**Nuclear Fuel Services, Inc.**  
P.O. Box 337, MS 123  
Erwin, TN 37650

**Subject: Clarification of NFS' Responses to the RAI Supporting NRC's Environmental  
Review for the BLEU Project**

***Clarification of NFS' Responses to the Request for Additional Information  
Supporting NRC's Environmental Review for the BLEU Project***

***Boring Logs, Well Installation Diagrams, and Water Level Data  
For Former Wells SC-7 and 82***

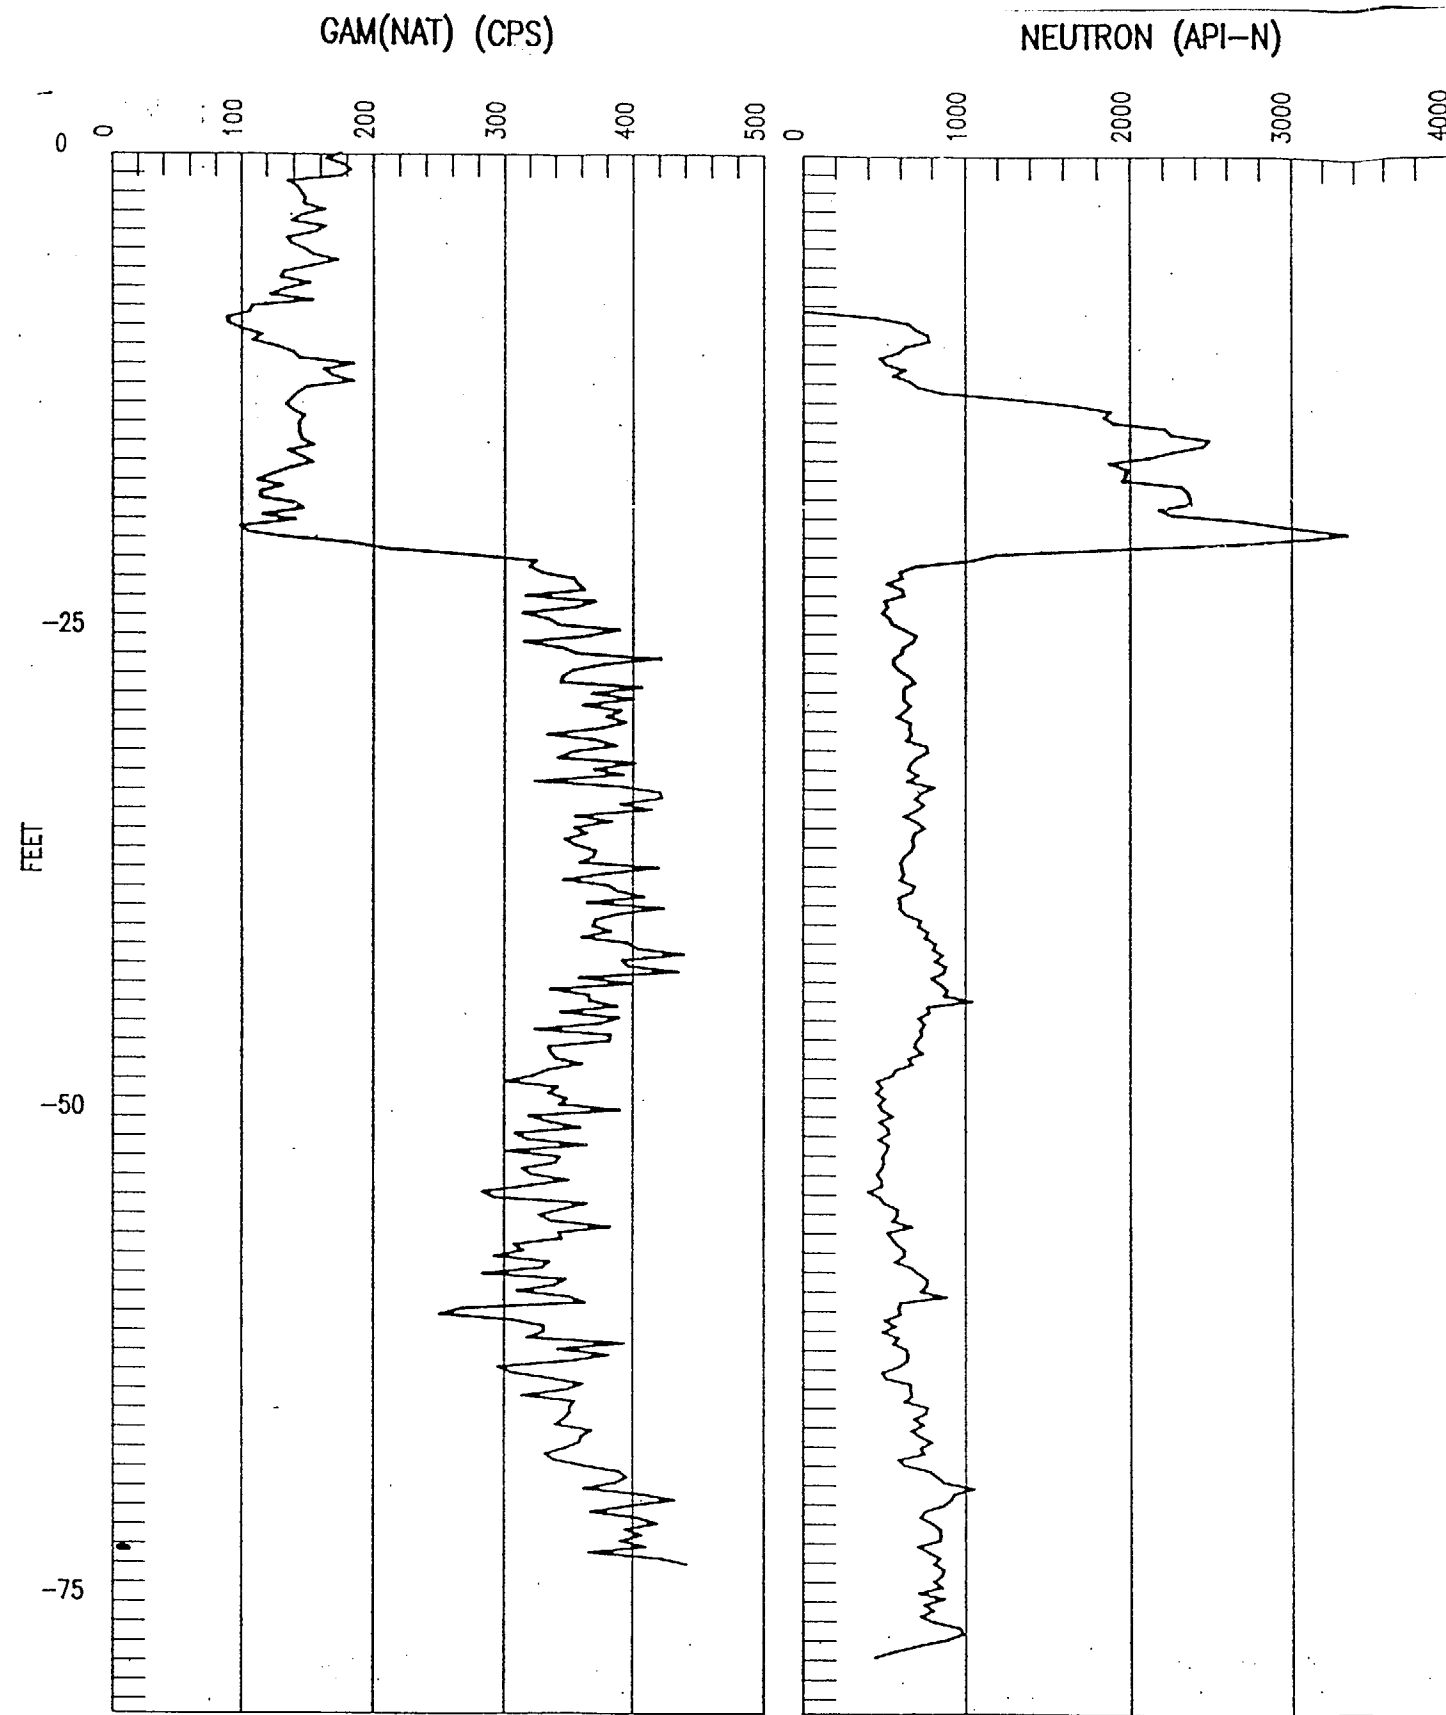
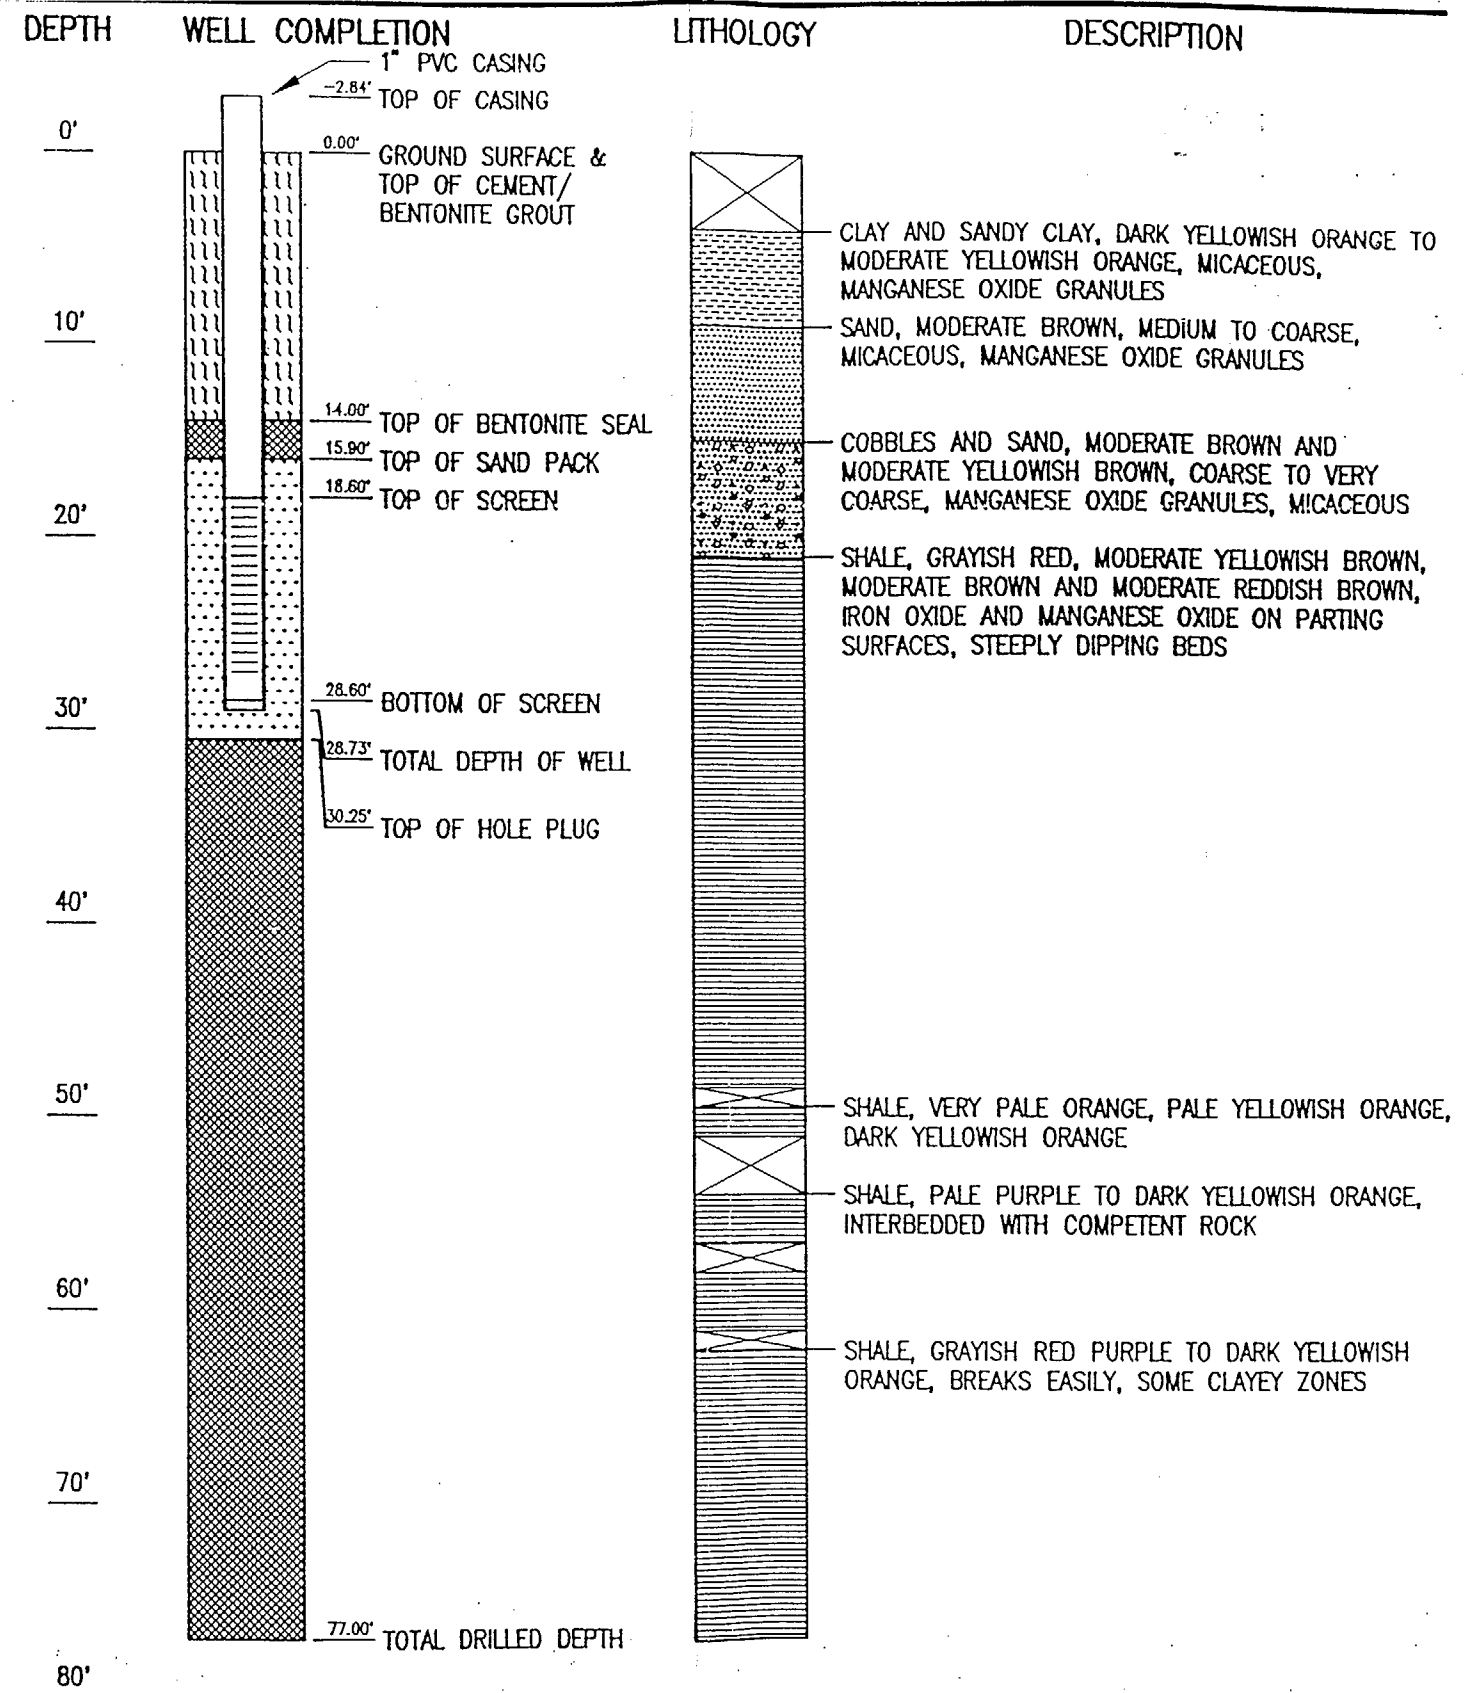
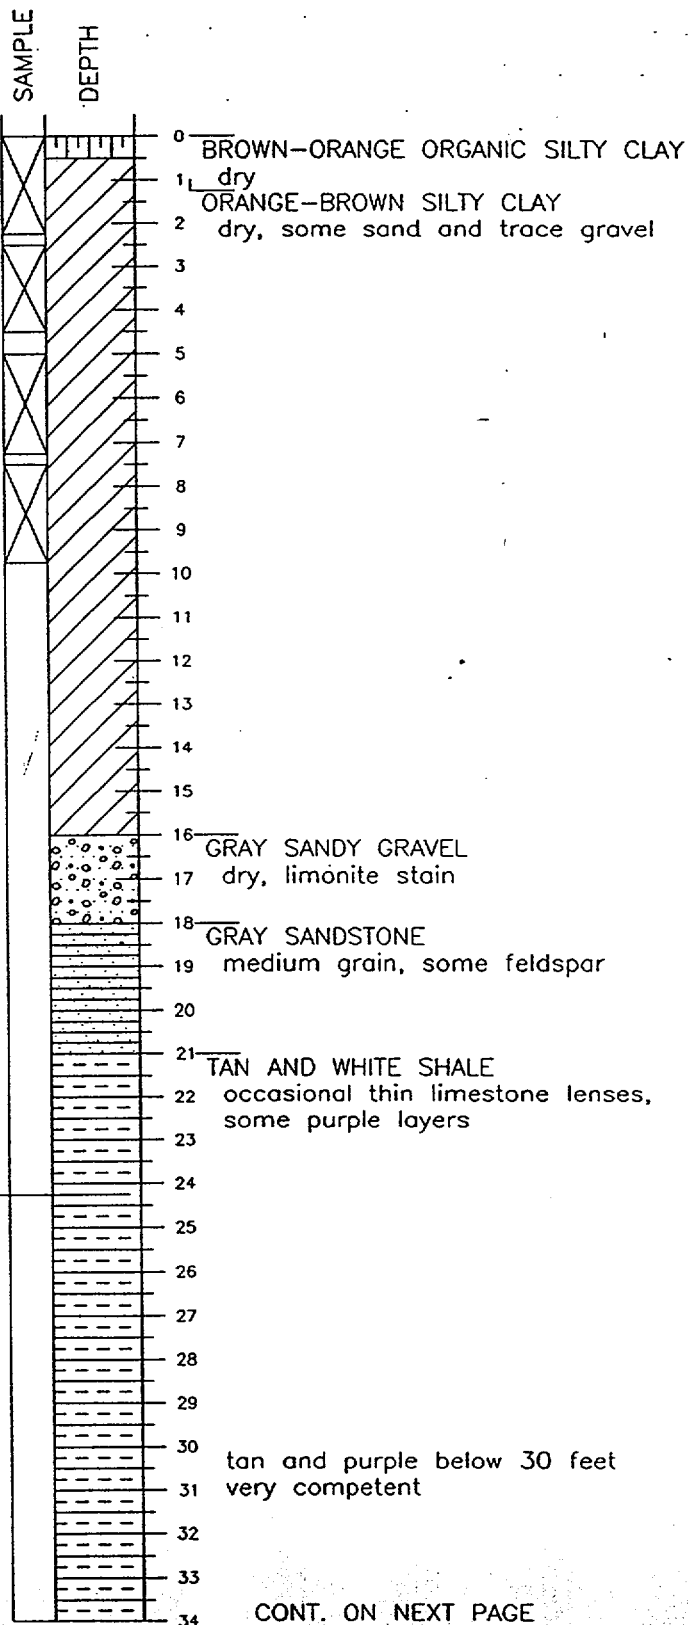
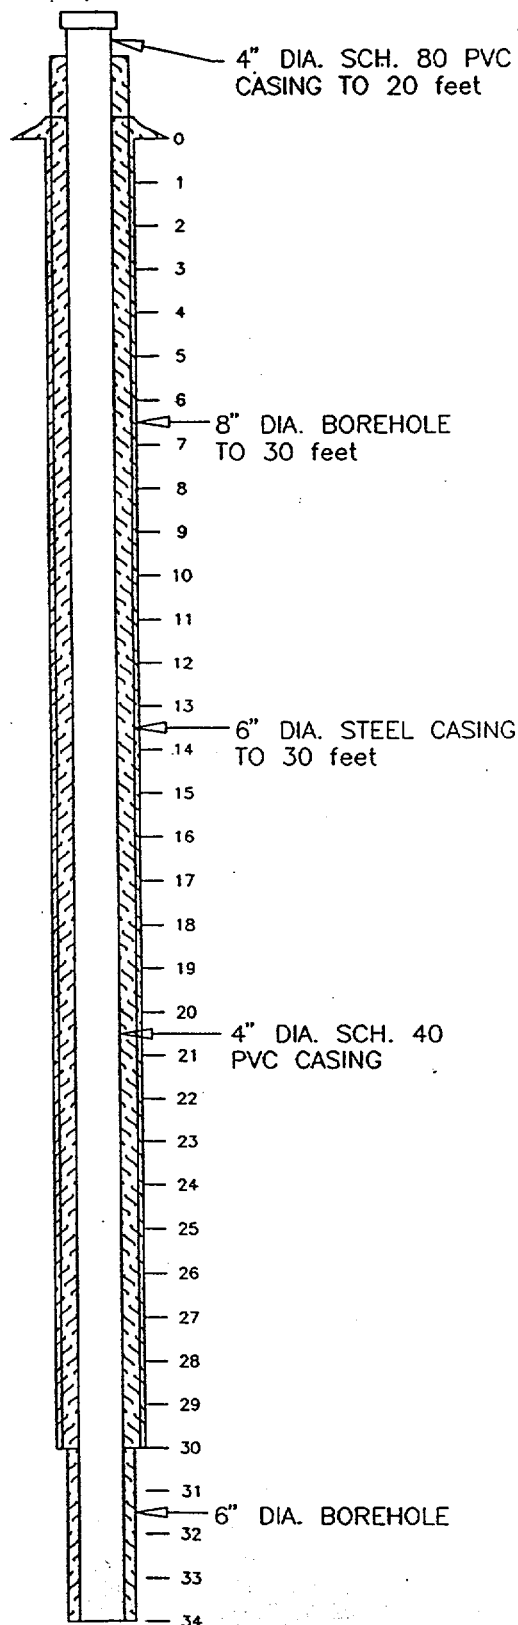
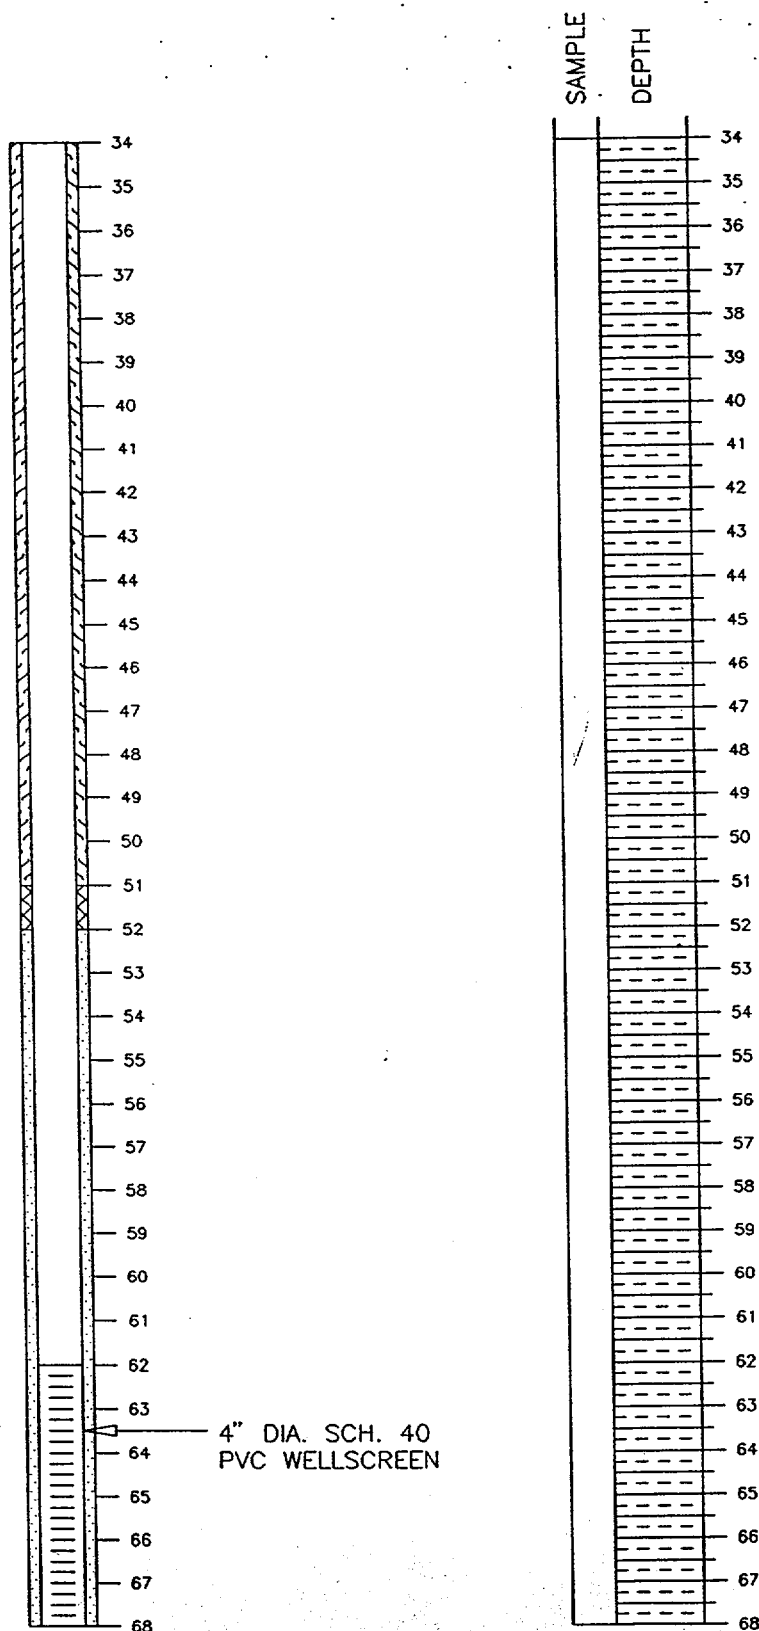
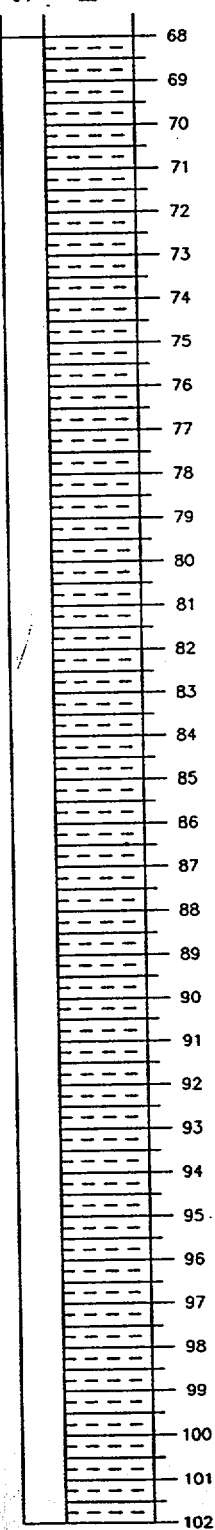
***NRC Comment 3: (RAI 21) Information on the hydrology at the proposed BLEU Complex location that was discussed during the last meeting was not included in the RAI package. This includes zone depths, water levels, brief info generally describing that a baseline characterization would be done. NFS agreed to provide.***

**NFS Response to Comment 3:** Attachment III of this submittal provides boring logs, well installation diagrams, and water level data for wells SC-7 and 82 that were located on the proposed BLEU Complex site. A description of the baseline characterization is provided in the response to Comment 5.
